PCN# : P64IAAB
Issue Date : May. 04, 2016

Information Only Notification

Description of Change (From) :

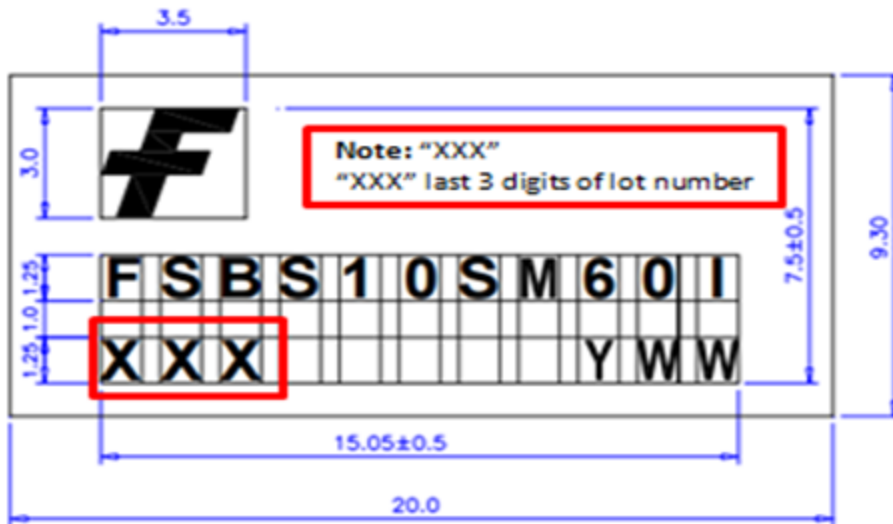
Marking layout : "XXX".

"XXX" is last 3 digits of assembly lot number.

Description of Change (To) :

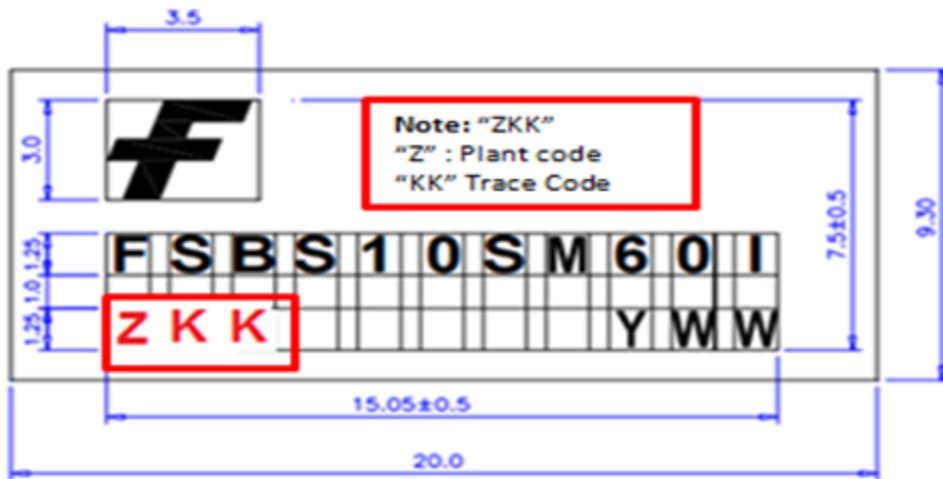
Marking layout : "ZKK".
"Z" is plant code , "KK" is trace code.

Reason for Change:
Assembly lot traceability improvement.
